[Docket No. 2000-SW-12-AD]

Airworthiness Directives; Eurocopter France Model AS350B, B1, B2, B3, BA, C, D, D1, and AS355E, F, F1, F2, and N Helicopters

ACTION: Supplemental notice of proposed rulemaking; reopening of comment period.

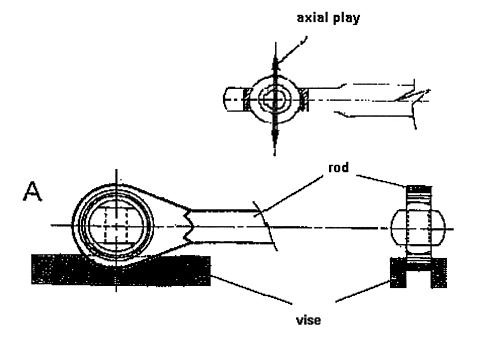
(a) Before the first flight of each day, place the tail rotor pedals in the neutral position. If the helicopter is fitted with a tail rotor load compensator, discharge the accumulator as described in the rotorcraft flight manual. Check the bearing for play on the helicopter, by observation and feel, by slightly moving the tail rotor blade in the flapping axis while monitoring the bearing for movement. *See* the following Figure 1 of this AD:

(1) If the Teflon cloth is coming out of its normal position within the bearing, totally or partially, or if there is discoloration or scoring on the bearing, the bearing is unairworthy. (2) An owner/operator (pilot) holding at least a private pilot certificate may perform this check and must enter compliance into the aircraft maintenance records in accordance with 14 CFR 43.11 and 91.417(a)(2)(v).

Figure 2: Measurement of the Axial Play (A) of the Bearing

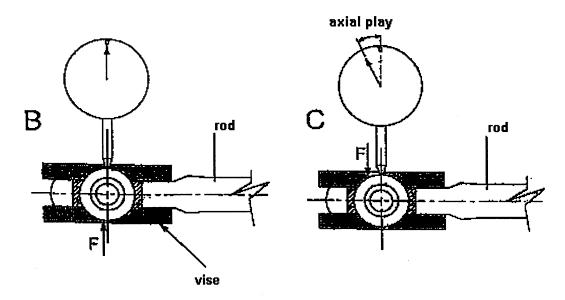
The manufacturer requests that the proposed Figures 1 and 2, relating to the axial and radial play measurements, be replaced with three clearer figures provided by them. The FAA agrees. Published Figure 1 gives the method only for a visual check. Published Figure 2 shows the complete assembly of the control rod and makes it appear that the measurements can be made without removing the control rod from the helicopter. Therefore, the FAA is inserting the three clearer figures in the proposal to clearly depict the measurement of radial and axial play and is including references in the text accordingly.

(b) If a pilot or mechanic detects play, a mechanic must remove the control rod from the helicopter, and using a dial indicator, measure the bearing wear according to the following and as shown in Figures 2 and 3 of this AD:

(2) Mount the control rod in a vise as shown in Figure 2 of this AD.

(3) Using a dial indicator, take axial play readings by moving the spherical bearing in the direction F (up and down) as shown in Figure 2 of this AD.

(8) If the radial play exceeds 0.008 inch or axial play exceeds 0.016 inch, replace the

Figure 3: Measurement of the Radial Play (R) of the Bearing

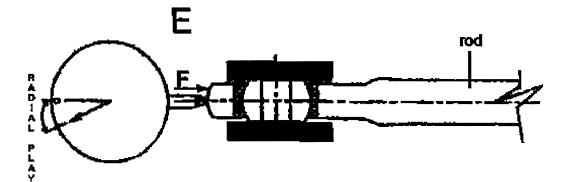
(5) Mount the bearing in a vise as shown in Figure 3 of this AD.

(6) Using a dial indicator, take radial play measurements by moving the control rod in the direction F as shown in Figure 3 of this AD.
